**SUSQUEHANNA STEAM ELECTRIC STATION
PROPOSED AMENDMENT NO. 195 TO LICENSE
NO. NPF-22: EXIGENT REQUEST TO SUPPORT
APRIL 8, 2000 RHR LLRT NOED
PLA-5180**

Docket No. 50-388

**PROPOSED AMENDMENT NO. 195 TO LICENSE NO. NPF-22:
EXIGENT REQUEST TO SUPPORT APRIL 8, 2000 RHR LLRT NOED**

**SUSQUEHANNA STEAM ELECTRIC STATION
UNIT NO. 2**

SKETCH OF SPECTACLE FLANGE

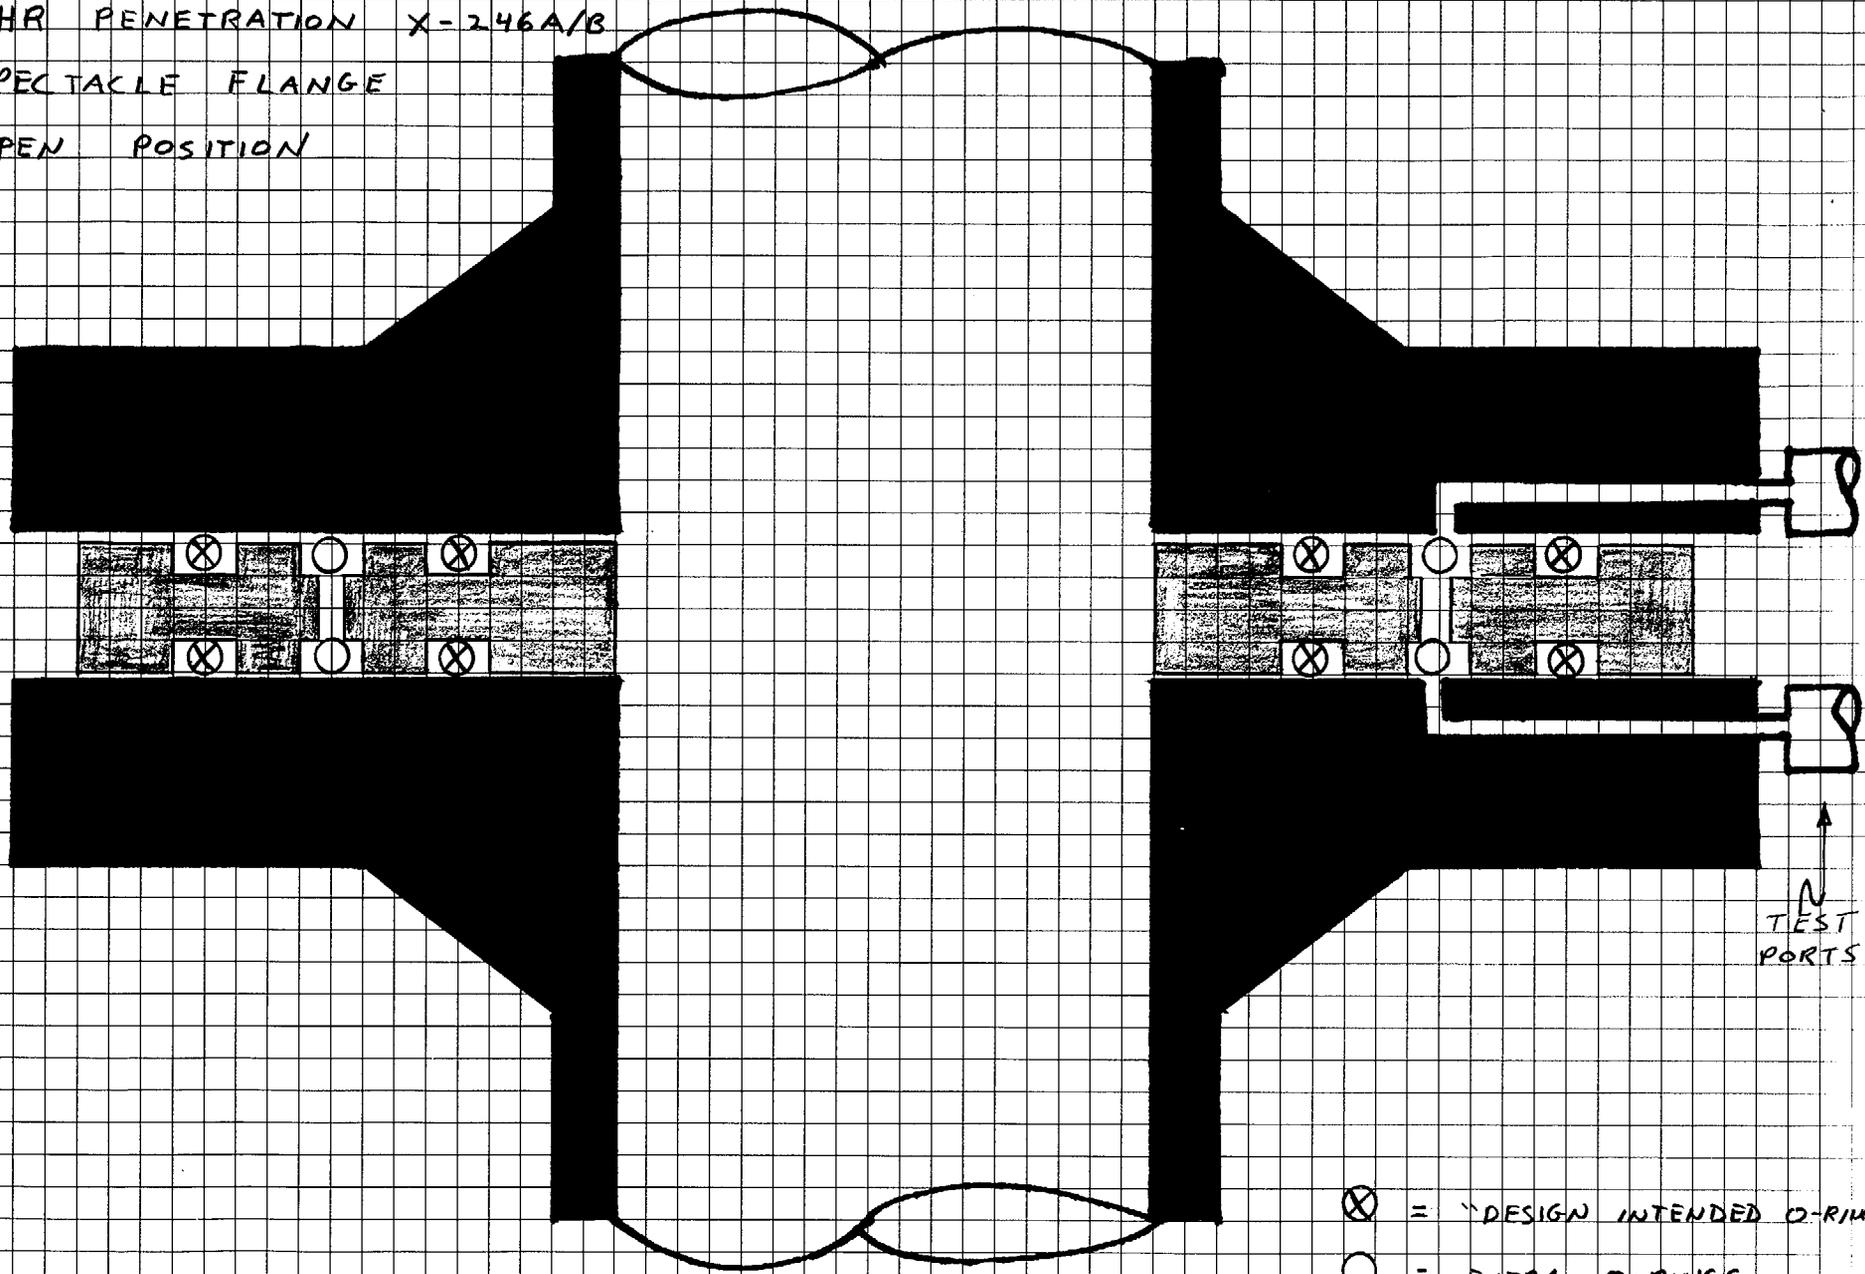
During close-out of the Unit 1 LLRT of the 1S299B o-rings during the Unit 1 Refueling and Inspection Outage, the LLRT work crew questioned the design of the spectacle flange and o-rings (See the attached figure). The LLRT crew rotated the spectacle on April 6, 2000 and installed an o-ring in all 3 grooves on each side of the spectacle (per the work plan). The purpose of the spectacle is to provide a barrier to test against when performing the LLRT on the containment isolation valves.

Research into the number of o-rings to be installed revealed that the design requires installation of 2 o-rings per flange: one o-ring in the inner groove and one o-ring in the outer groove. The purpose of the middle groove is to have a place to test the inner and outer o-rings and to tie together the flanges on either side of the spectacle. This allows the flanges on both sides of the spectacle to be tested at one time. With an o-ring (with grease) in the middle groove, it cannot be demonstrated positively that the containment boundary (i.e. the o-rings) has been adequately tested. The o-ring in the middle groove may adversely affect proper pressurization of the the inner and outer o-rings.

Since the work plan for the Unit 1 spectacle flange o-rings specified 3 o-rings per flange face in conflict with the design intent, the status of the o-rings in the Unit 2 spectacle flanges were checked. Based on a document review, it was identified that 3 o-rings are installed on each side of the Unit 2 2S299A and 2S299B spectacle flanges. The documentation shows that in 1997 only 2 o-rings (inner and outer) were found per side when the spectacles were initially rotated to the closed position to perform the LLRTs on the RHR heat exchanger relief valves. When the spectacles were rotated back to the open position, 3 o-rings (inner, middle, and outer) were installed per side in accordance with the work plan.

The existence of the third o-ring per face in spectacle flanges 2S299A and 2S299B does not affect the pressure retaining ability of the pipe flange to spectacle flange interface. The third o-ring does however, potentially affect the ability to positively confirm their performance. The presence of the third o-ring is likely to improve the pressure retaining capability of the pipe flange to spectacle flange interface. The spectacle flange is a static device that uses o-rings for sealing. The groove this third o-ring occupies is machined to the same dimensions as those grooves intended to house o-rings for sealing. The o-ring installed in the center groove is also of the same material and width as those intended for sealing. Since this additional o-ring meets the design and installation requirements for those intended for sealing, it should provide an additional barrier against leakage. The condition of the spectacle flanges with three o-rings is at least as good if not better than the double o-ring design. Therefore, the safety basis for this request is that the deficient condition does not degrade safety.

"Not required to be performed on the 2S299A and 2S299B spectacle flange o-rings until the Unit 2 10th refueling outage (Spring 2001) or a prior Unit 2 outage requiring entry into Mode 4."

The middle o-ring currently believed to be installed on both the 2S299A and 2S299B spectacle flanges should be removed in order to perform the LLRT as required. Removal of the middle o-ring would require breach of the primary containment boundary rendering the primary containment inoperable.
